Your Reference 22/02009/FULL and 22/02163/LBC

Old Brewer's Yard, 28-32 Shelton Street, 15A Neal Street, 5 and 7 Langley Street, 1 and 3 Mercers Walk and 107-115 Long Acre

The revised design

Fig. 10 View of model showing junction with adjacent building to the West

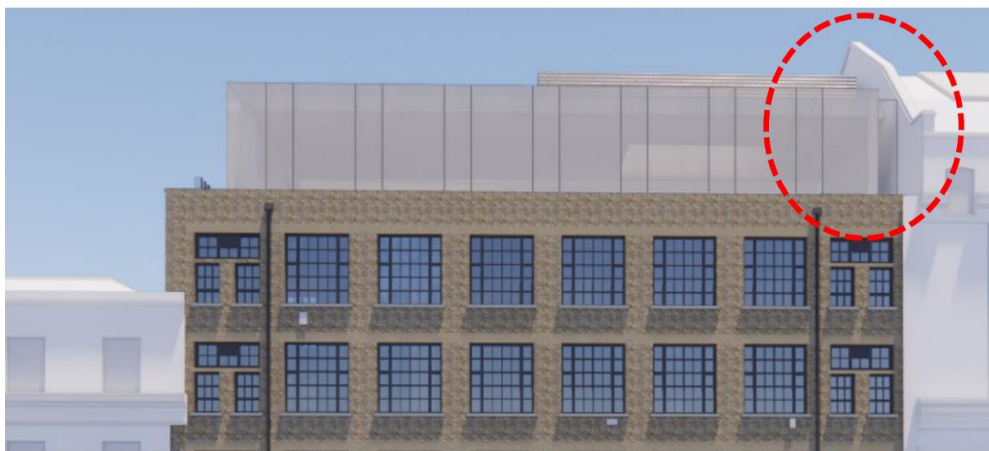
The Seven Dials Trust considers that the proposed roof extension is not an appropriate design for this traditional, brick faced semi-industrial building. The extension does not follow an established form, which will help unify the architectural character of the existing group of buildings. It would be alien to the character and appearance of the building, the streetscape and the Covent Garden Conservation Area.

1. The proposed glazing is only set back 1280 mm from the facade. This is not sufficient to reduce its visual impact in a meaningful manner.
2. The roof extension at 25-33 Shelton is set far enough back from the facades that it is not visible from street level. It is certainly nowhere near as visible as the proposed roof extension will be.
3. The impact of the roof extension will be harmful during the day but also at night when it will be illuminated from within.

We consider that a glazed roof extension which is barely set back from the façade would be unprecedented in Covent Garden (or indeed the West End generally), which is a conservation area dominated by a traditional roofscape of pitched roofs, covered in slates or lead. If there are modern roof extensions (and there are few) then they are set back so far that they have little or no visual impact from street level.

1. the extension was set back further from the front façade.
2. the height of the proposed glazed facade was reduced.
3. the degree of glazing was reduced.
4. the design was more closely related to the architecture of the facade below.
